ATTACHMENT C

Summary Description of Technical Specification Changes

ATTACHMENT D

Proposed Technical Specification Changes

Figure
3.10-1

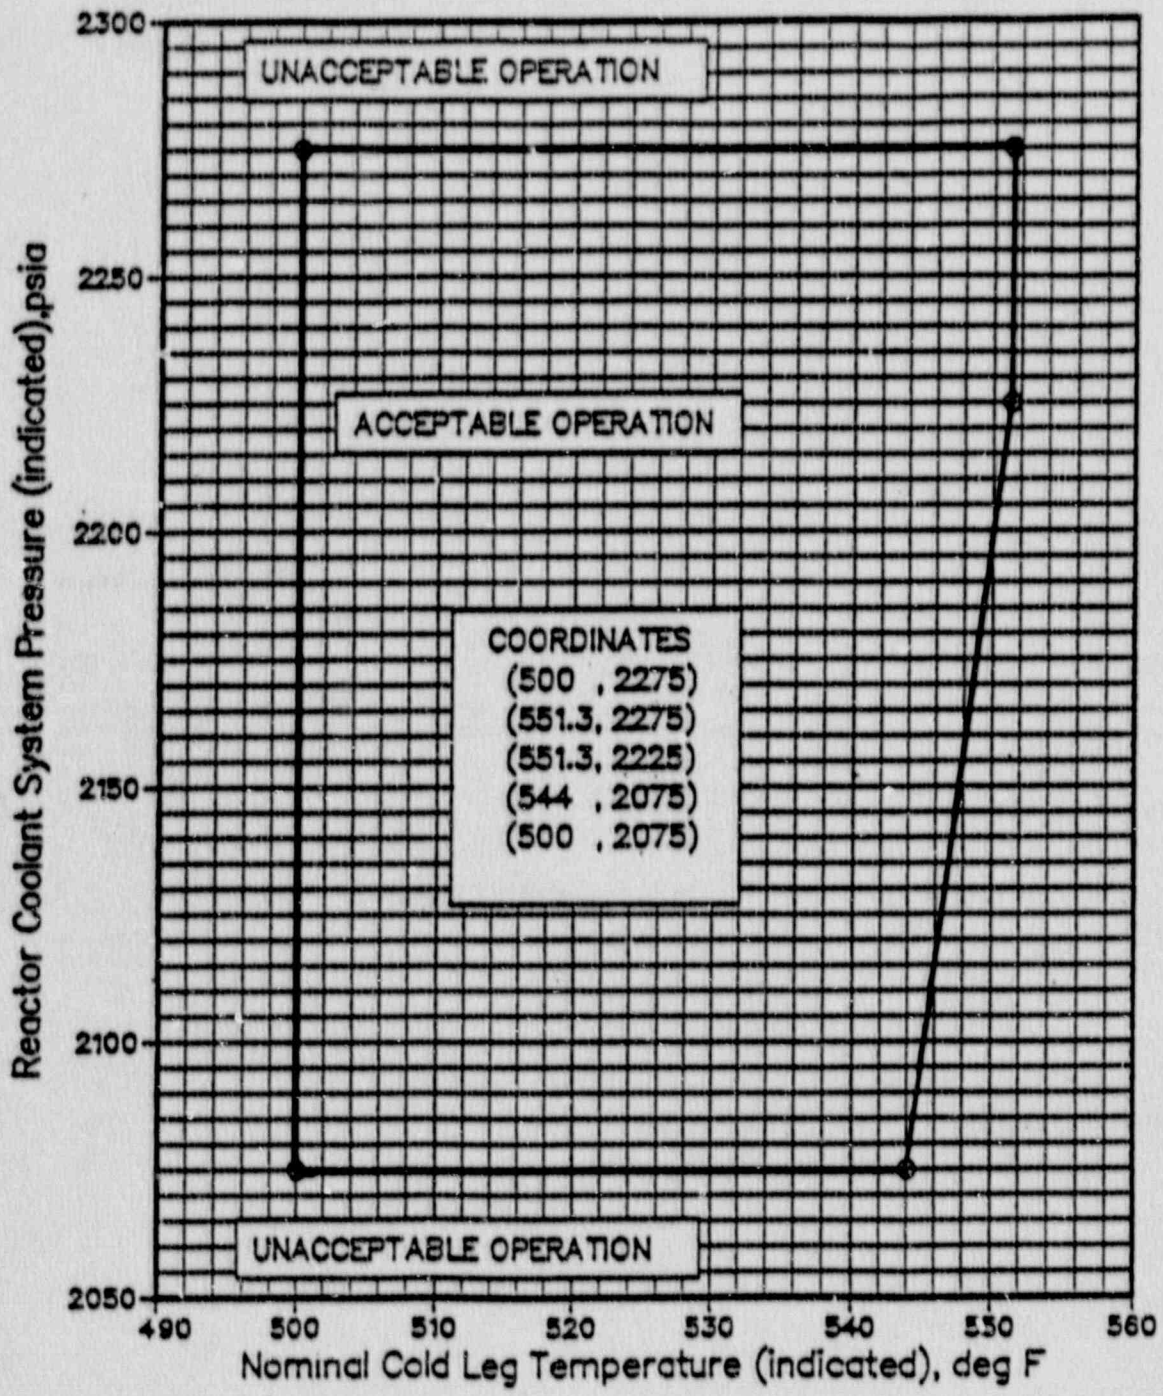
Item No.	Technical Specification	Description of Change	Reason for Change
	3.10-6	Moved the Symmetric Offset LCO for both normal and IMPIN operation to the Core Operating Limits Report.	Both limits are cycle-specific.
		Figure 3.10-10 renumbered to figure 3.10-1.	Admini.
		Figure 3.10-6 renumbered to Figure 3.10-2.	Administrative.
		Renumbered page.	Administrative.

Except during low power physics testing the MTC shall be less positive than that shown in Figure 3.10-1.]
